# E17-49015-00

## 46640 TO 46641

# FIRMWARE UPGRADE

# KIT

FIG. 1 - 46020 MAP EPROM LOCATION

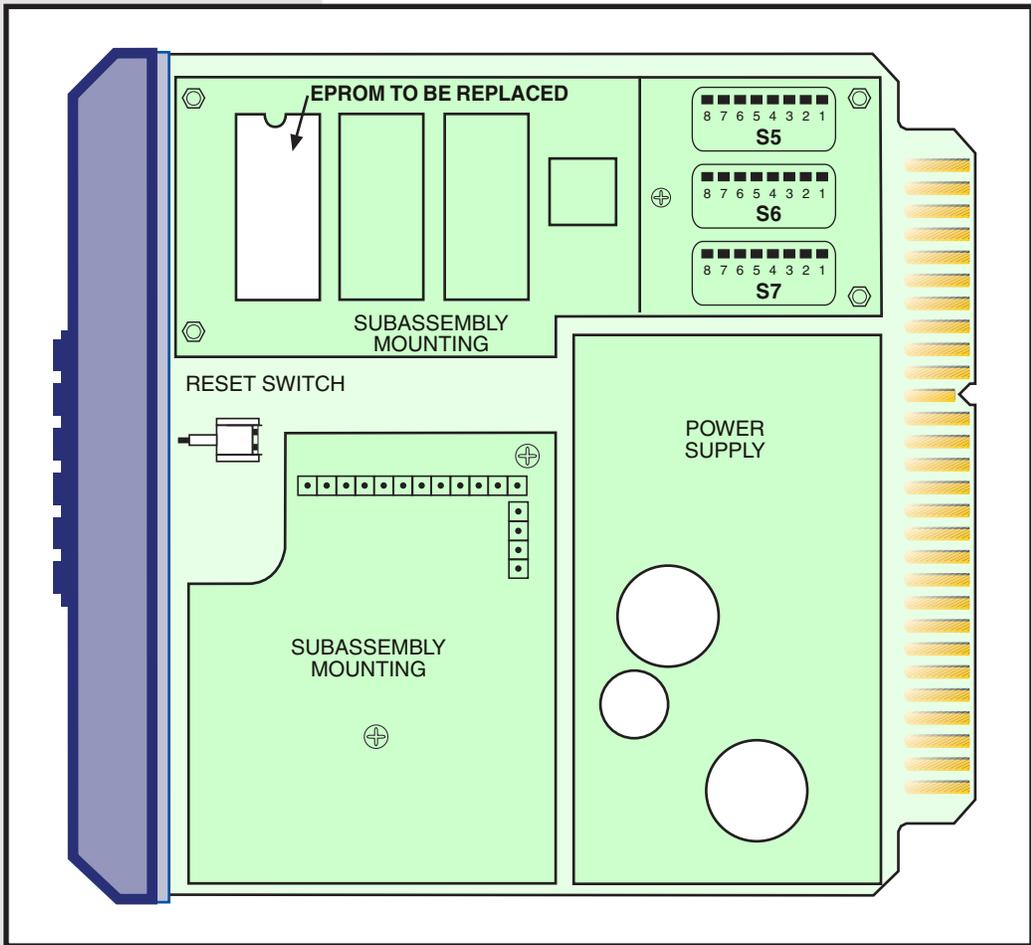
1. Remove the module to be upgraded and place the module on an ESD approved work area. The component side should be up and the blue handle to the left.
2. The EPROM to be removed is located in the top left corner of the module (Refer to Fig. 1) and is labeled x82-00308-00. Before removing this chip, note its orientation. (The notch is toward the top of the module.)
3. Remove the old EPROM by pulling straight up on the IC. It may be necessary to use a small screwdriver to gently pry the old EPROM up.
4. Discard the old IC.

1. Install the replacement EPROM, labeled F82-00351-00, in the socket. Verify that the orientation is the same as the old EPROM.
2. Applying even pressure, push the IC into position. Exercise caution not to bend any pins on the IC.

1. On the firmware subassembly, just below the EPROM, is a label. If that label is marked x17-46640-01, replace it with the new label D17-46641-00.
